49 CFR Part 571

[Docket No. NHTSA-2010-0021]

Federal Motor Vehicle Safety Standards; Electric-Powered Vehicles; Electrolyte Spillage and Electrical Shock Protection

ACTION: Final rule.

Figure 1. S7.6.3 and S7.7 Measurement of Voltage Source Voltage

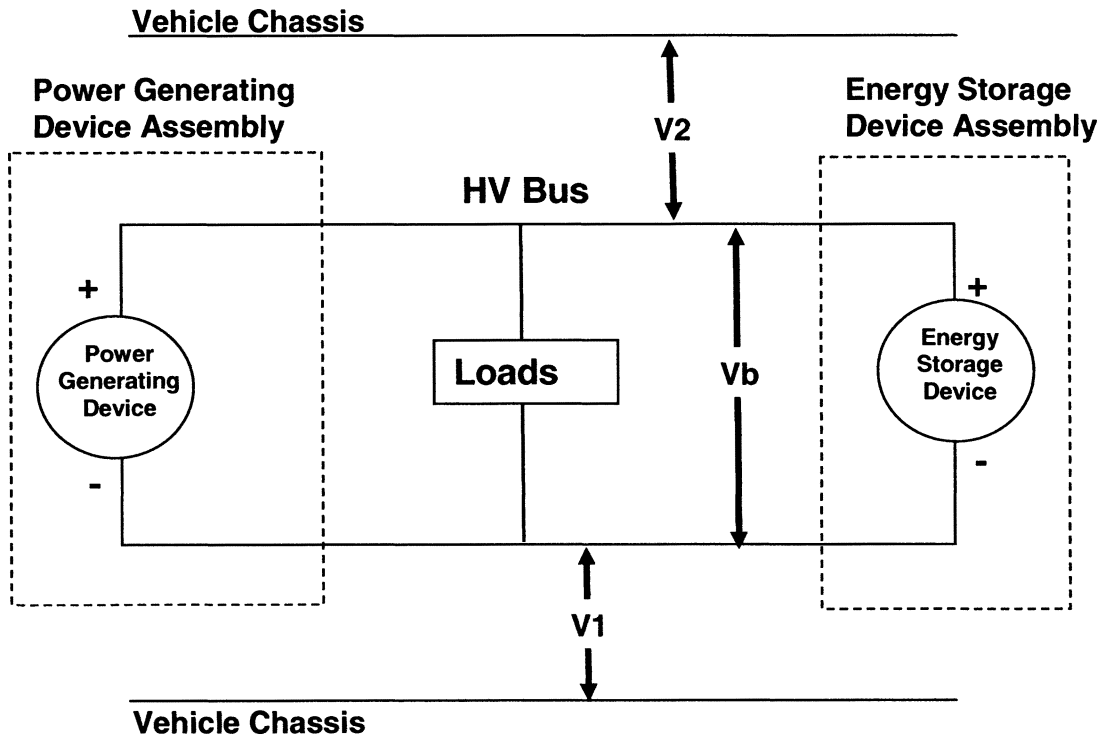
And fifth, the Alliance/AIAM suggested the following editorial corrections: Figure 1 should refer to S7.6.3, not S7.6.6; in Figure 4, V1 should be V1', and the denominator should be V1'; and in Figure 5, the denominator should be V2'.

We agree with these corrections and have revised the regulatory text accordingly.
